OPTIONAL SERVICE BULLETIN NO. 40NG-032 REV. 2

SUPERSEDES OSB 40NG-032 REV. 1

Installation provisions for a safety mesh to protect the fuel tank vents.

PROJECT		
TITLE		
PROVISIONS FOR FUEL VENT COVER INSTALLATION LH/RH		
DWG. ORIG.	DWG. NO.	REV
DAIA	D4D-5741-00-00X03	-
	D4D-5742-00-00X03	
CODE 710197	SCALE 1:20, 1:1	SH 01 OF 01

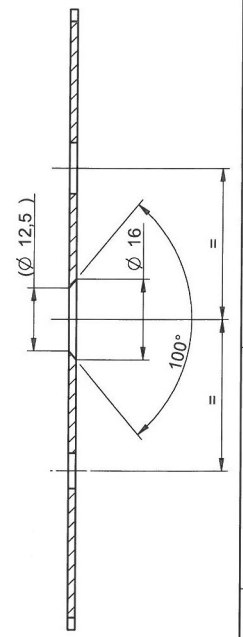
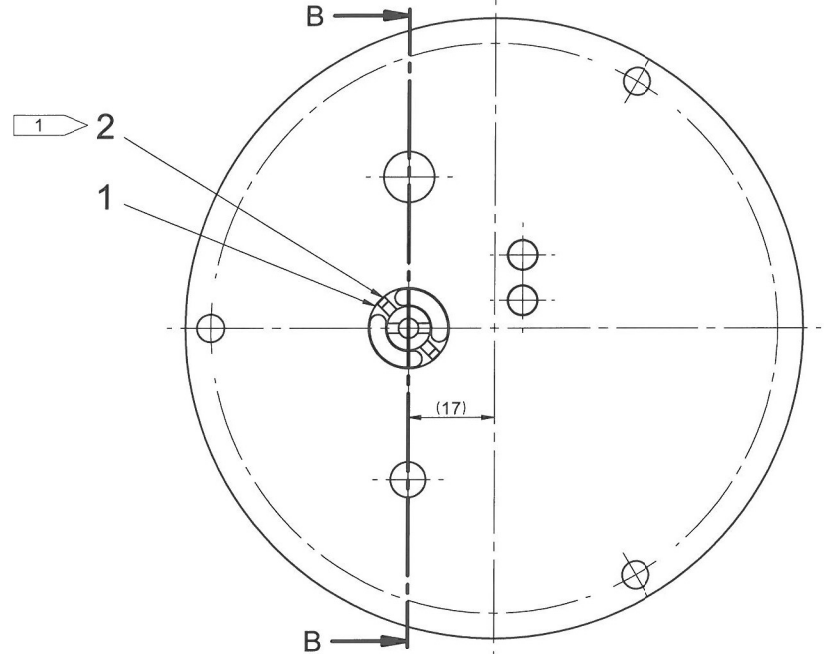
Drill a hole in the fuel vent cover system; install a camloc and retaining nut i.a.w. drawing:

FLAG NOTES
1. SECURE USING THICKENED RESIN
